Combined Feasibility / System Impact Study Report

Queue Project AF2-184

MCCONNELLSBURG-MERCERSBURG 34 KV II

July 2020

16 Attachment 1: One Line Diagram

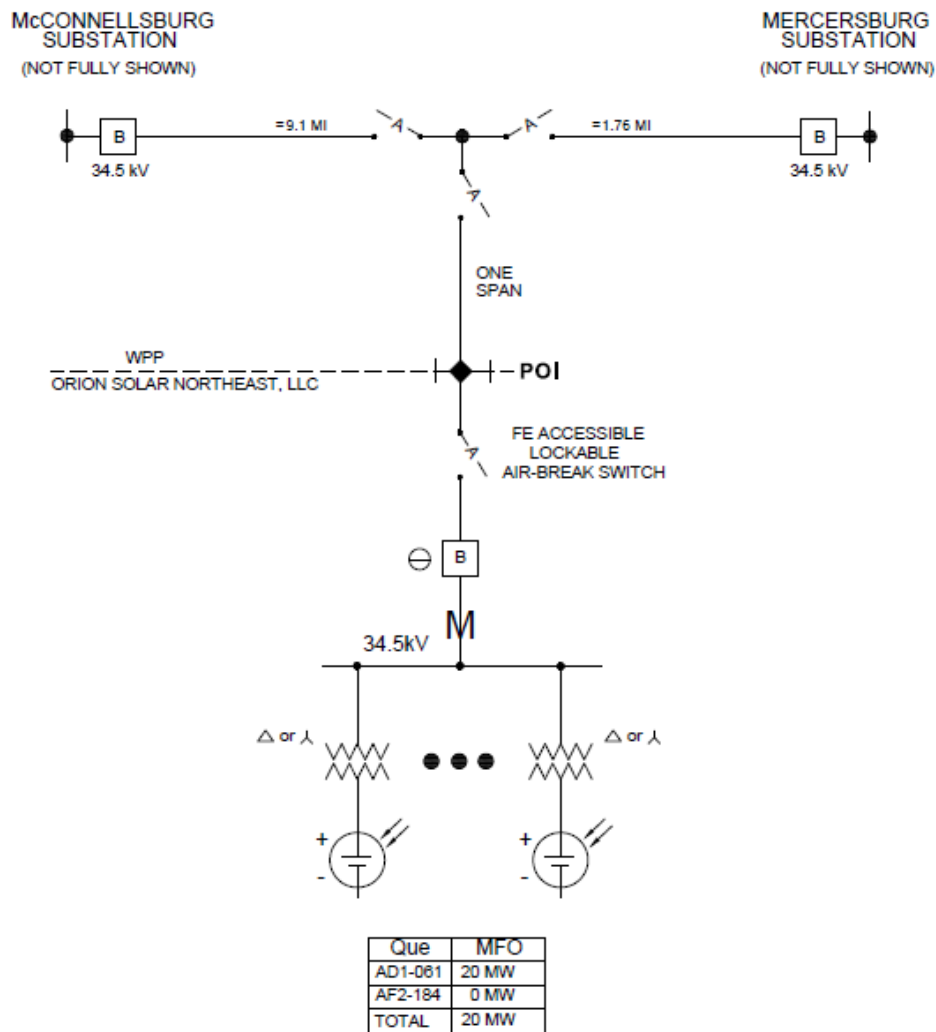
The IC has requested a non-standard GSU transformer winding configuration. This transformer is in violation of section 14.2.6 of FE's "Requirements for Transmission Connected Facilities" document and will not be accepted. The GSU transformer must have a delta or ungrounded wye connection on the high (utility) side and the low side at the discretion of the IC.
